Field Report

DATE	Aug. 22, 2016	**REPORT NO.**	**001**
PROJECT:	Webster University Interdisciplinary Science Building 8274 Big Bend Blvd. Webster Groves, MO 63119	**DATE OF VISIT:** **TIME:** **WEATHER:**	Aug. 11, 2016 2:00 pm 91°F Sunny
PROJECT #	004560.01		
PRESENT AT SITE:	Kelvin Patel, Kathy Williams, Scott Klingsick

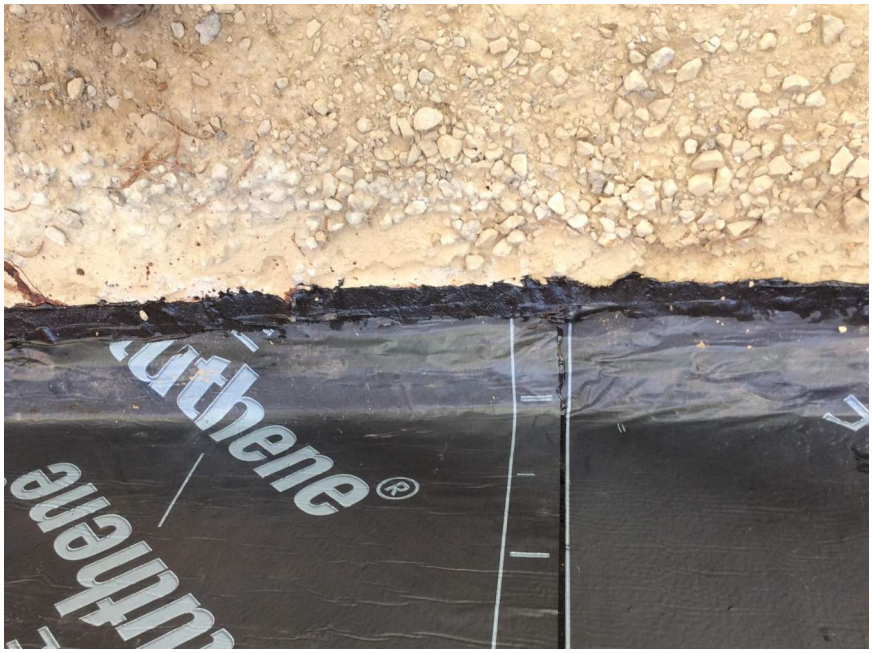
2. Top of grade beams not screed for adhesion of waterproofing membrane.
ACTION: Per discussion in waterproofing pre-installation meeting the grade beam top will be ground to prepare a uniform leveled substrate per manufacturer's specification for adhesion of waterproofing membrane . Do not compromise cover of reinforcing - removal to be only as required for membrane attachment.

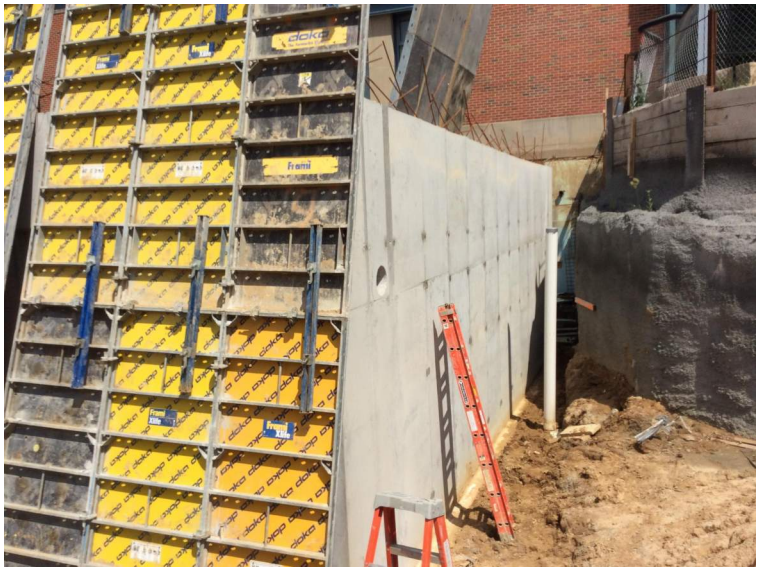
5. The green roof overflow drain penetration in the concrete wall at the south of the lecture hall on level 01 has crack around it.
ACTION: Repair crack - provide epoxy injection or hydraulic cement product data for approval.
